V2500-A5 SERIES PROPULSION SYSTEMS SERVICE BULLETIN

This document transmits Revision 1 to Service Bulletin V2500-ENG-73-0200 and Revision 1 to the Supplement

V2500-ENG-73-0200

ENGINE – FUEL AND CONTROL – REPLACEMENT OF RESISTORS AND TOUCH-UP OF SOLDER JOINTS
FOR ENGINES WITH EEC150-40 ELECTRONIC ENGINE CONTROL (EEC) INSTALLED

Family Tree - Electronic Engine Control (EEC) Ref. Catalog Sequence No. 73-22-34,
Fig. 01 Item 280
Chart A (Sheet 1 of 2)

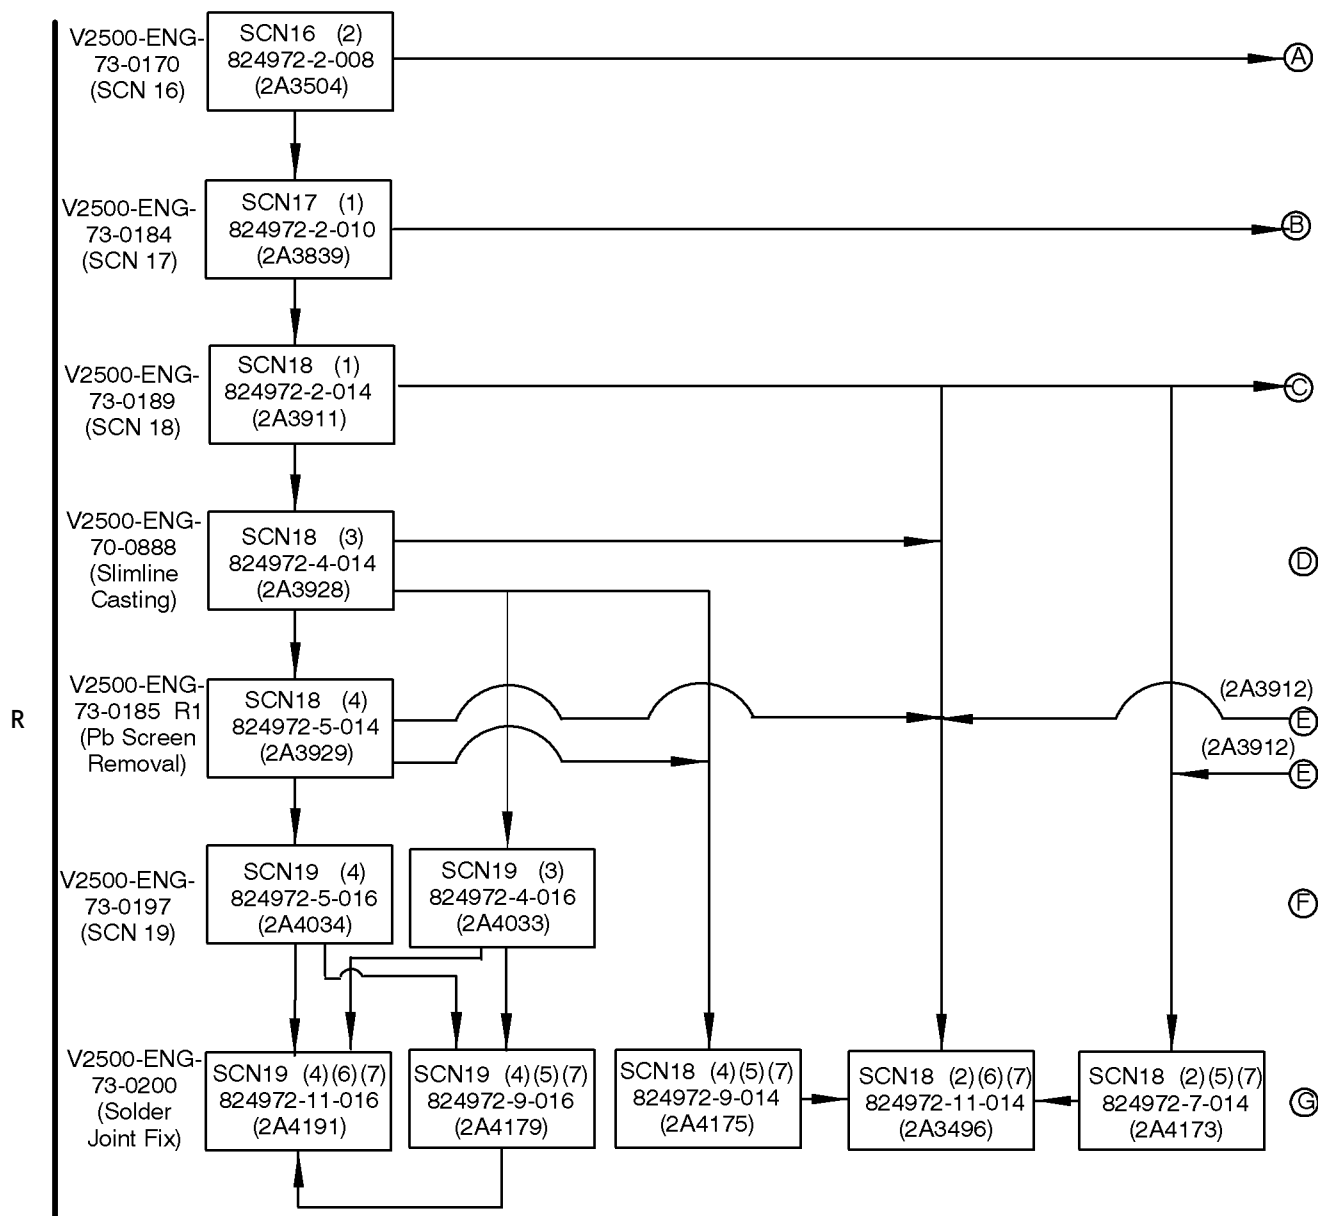
R Parts Progression To Show the Changed Part in Relation to Other Parts

- (1) With Pb Screen
- (2) No Pb Screen
- (3) With Pb Screen & Slimline Case
- (4) No Pb Screen & Slimline Case
- (5) The new part can be obtained by modification of the old part as specified in the Accomplishment Instructions.
- (6) The new part is a replacement part only, and cannot be obtained by modification of the old part.
- (7) With Reference 4., Service Bulletin No. V2500-ENG-73-0185 incorporated.

Family Tree - Electronic Engine Control (EEC) Ref. Catalog Sequence No. 73-22-34,
Fig. 01 Item 280

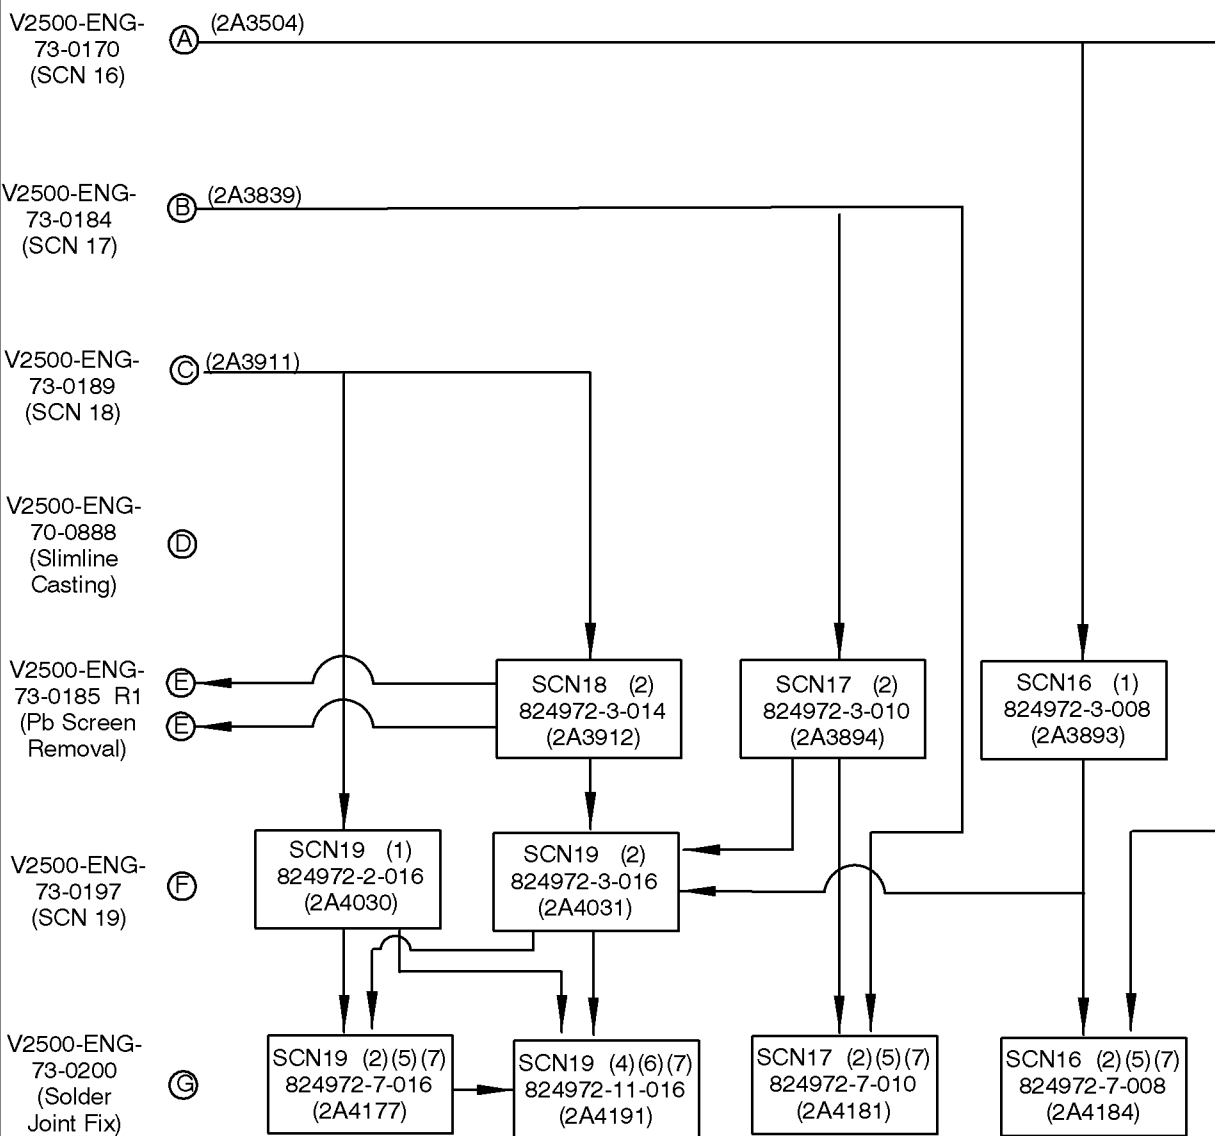
- (1) With Pb Screen
- (2) No Pb Screen
- (3) With Pb Screen & Slimline Case
- (4) No Pb Screen & Slimline Case
- (5) New part can be obtained by modification of the old part as specified in the Accomplishment Instructions.
- (6) New part is a replacement part only, and cannot be obtained by modification of the old part.
- (7) With Reference 4., Service Bulletin No. V2500-ENG-73-0185 incorporated.
